## Amendment Report (MOD-3)

State Significant Development (MP07\_0048-MOD-3)

Enviroking Liquid Waste Facility Project

843 John Renshaw Drive, Black Hill

Figure 1 Plan showing removal of tanks and equipment within the existing treatment shed.

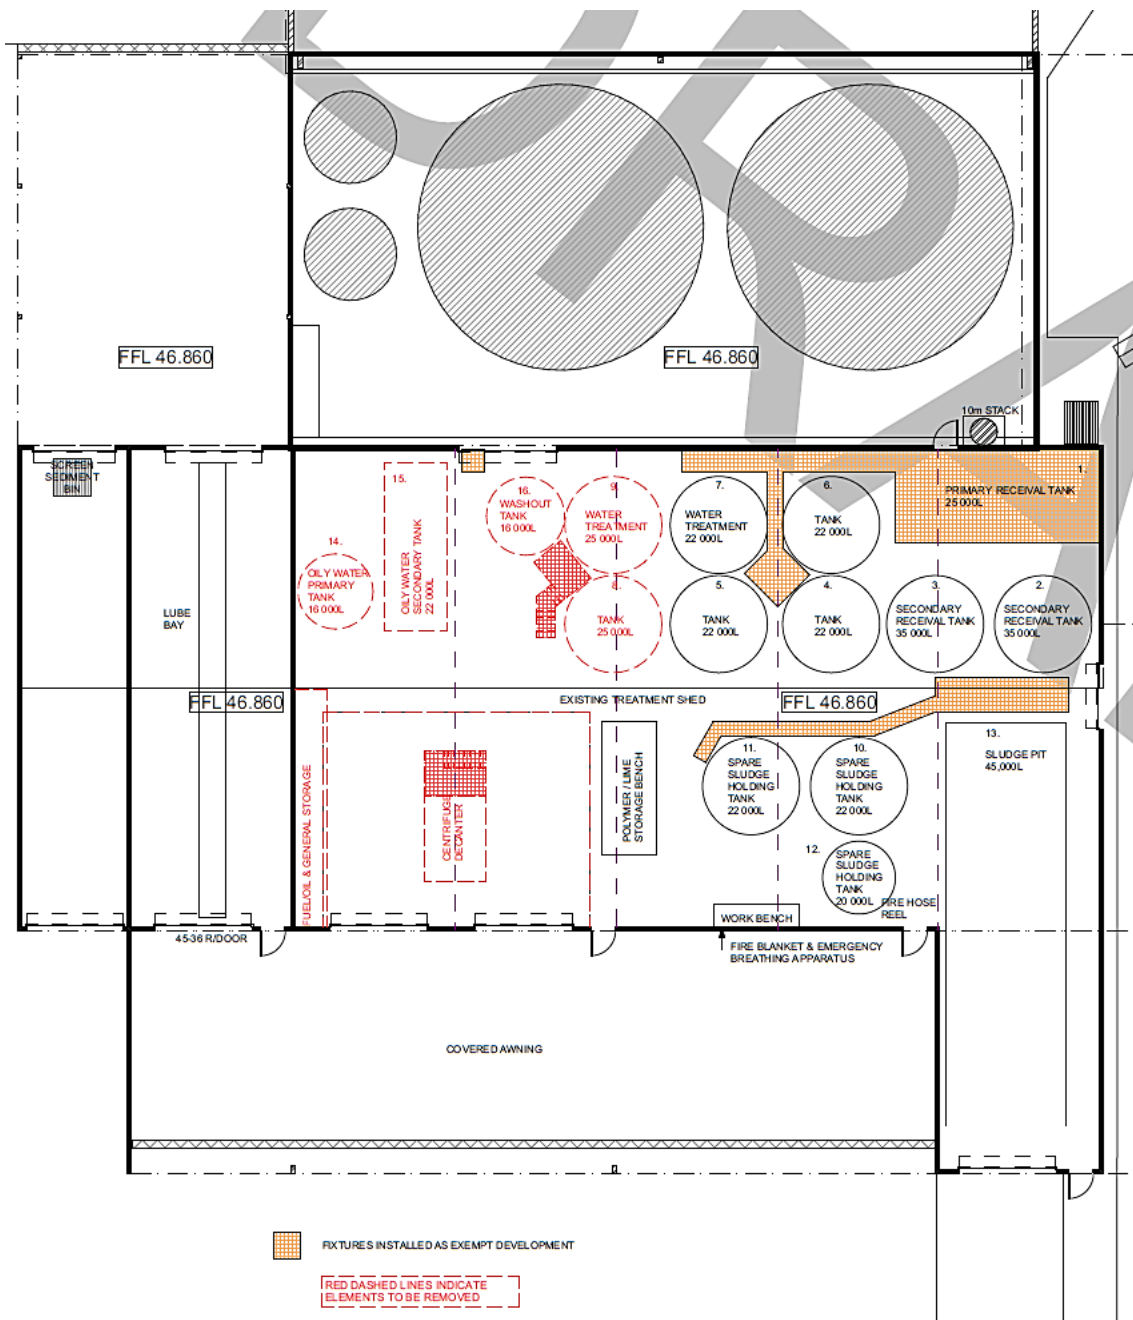
To accommodate the DAF Unit, changes to the internal layout of the treatment shed are required, are shown in **Figures 1 and 2**).

Figure 2 Amended plan of internal layout of main building showing treatment process and storage tanks

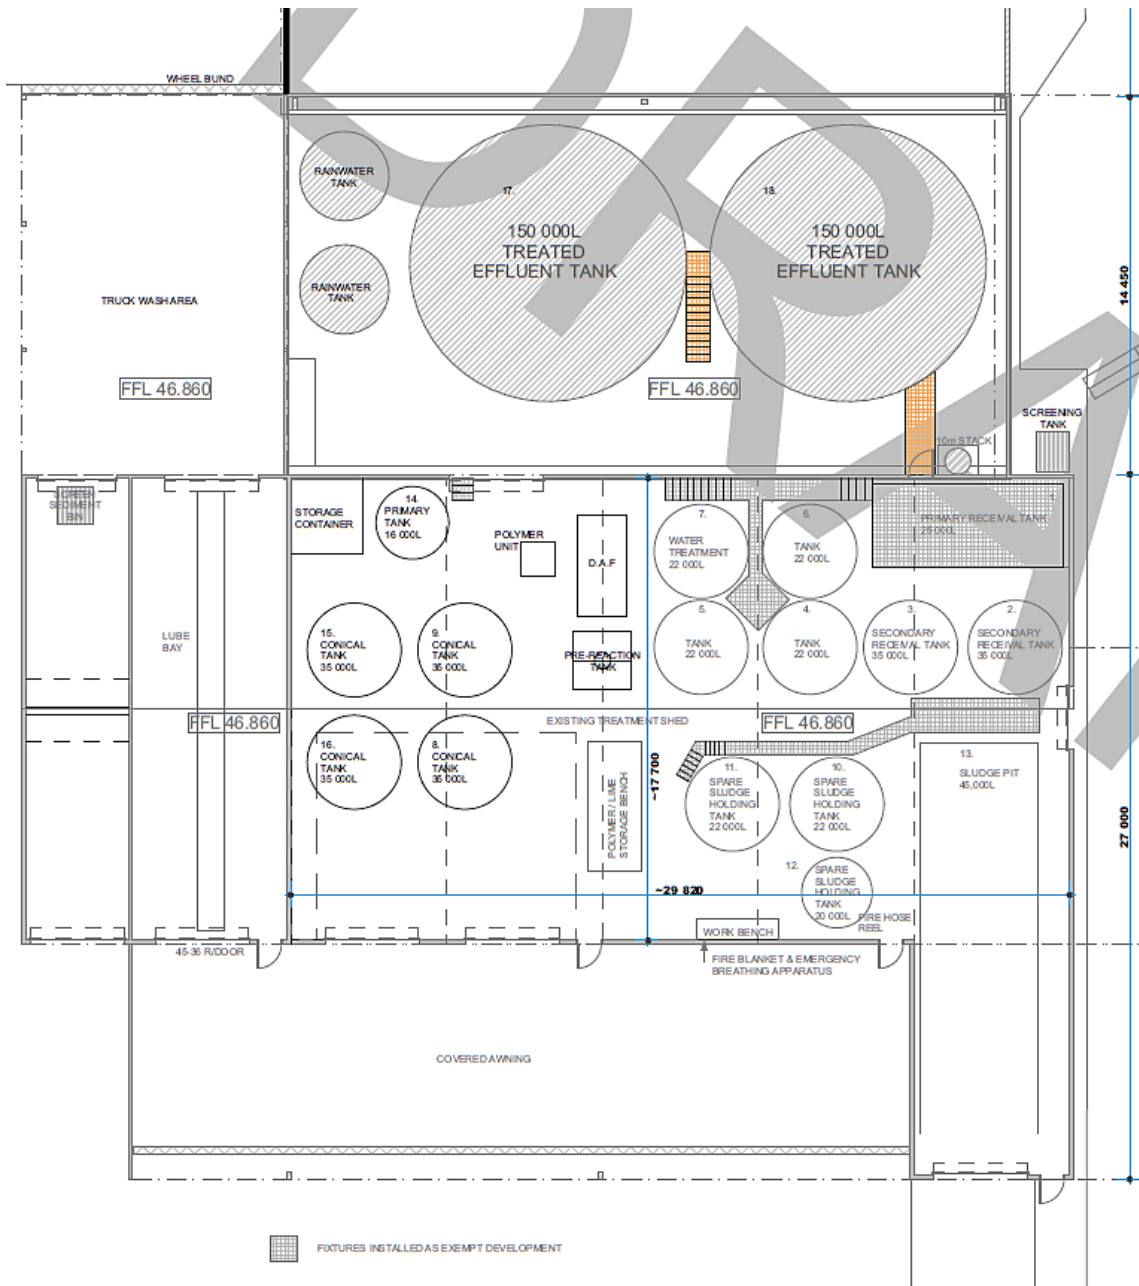
The key modifications to the layout can be summarised as follows:

Figure 3 Proposed treatment process (Source: SESL, 2025)

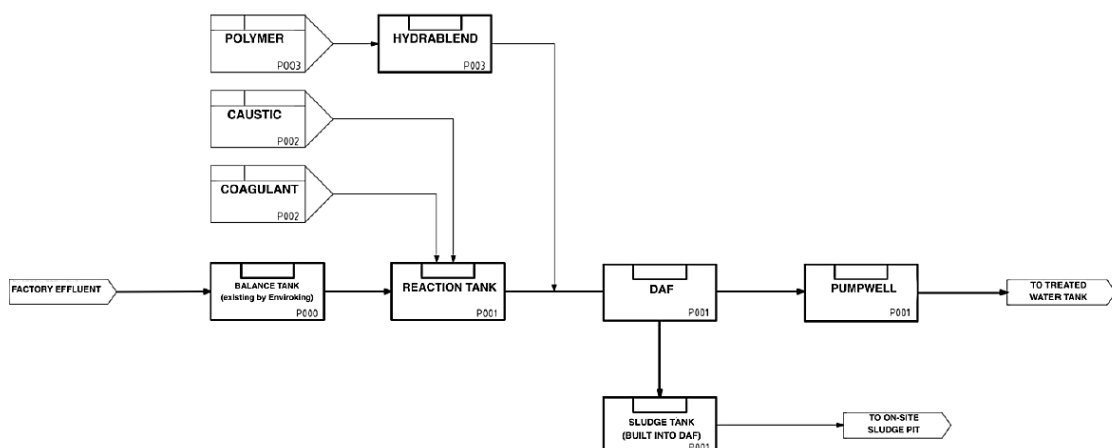
These vehicles then deliver the liquid waste streams to the site. Vehicles carrying grease trap waste (GTW) park on the eastern side of the waste treatment building and decant waste via gravity feed into holding tanks, prior to treatment in the processing tanks within the building. The GTW then undergo a series of treatments as shown in **Figure 3**, which includes:

- Solid matter from the primary treatment process is added to the dewatered sludge;
- The liquids are then transferred to temporary storage tanks (balance tanks) pending treatment in the DAF unit;

- Polymers, coagulants and pH balancing agent are then combined before processing the waste water in the DAF Unit; and
- Post-DAF treated waste water is then temporarily stored in tanks within the building and sludge pumped to sludge storage.

Figure 4 Extract of site plan showing location of awning addition (Source: Advantage, 2025).

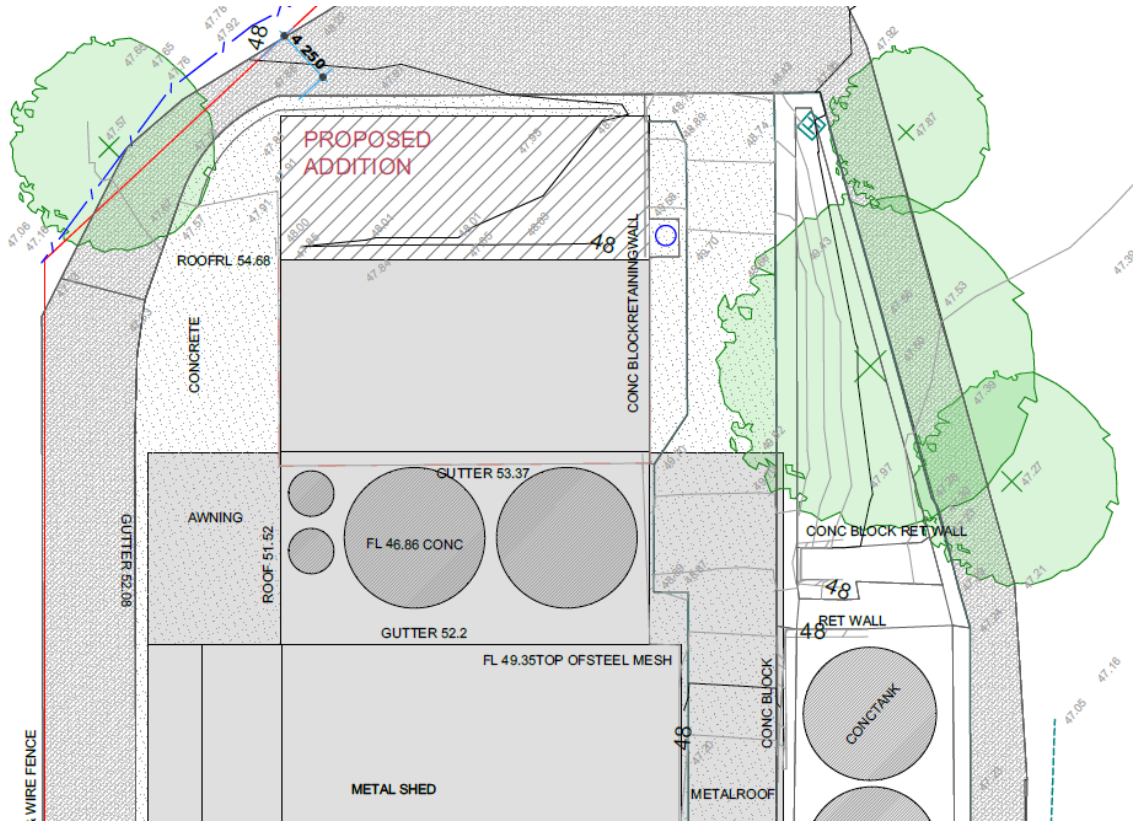
As a consequence of concerns raised by the EPA, it is proposed to undertake alterations to the existing rear awning in order to cover the existing hardstand area and enclose the sides of this space.

This awning addition is shown on the plans at **Appendices A and B**, extracts of which are provided at **Figure 4** and **Figure 5**.
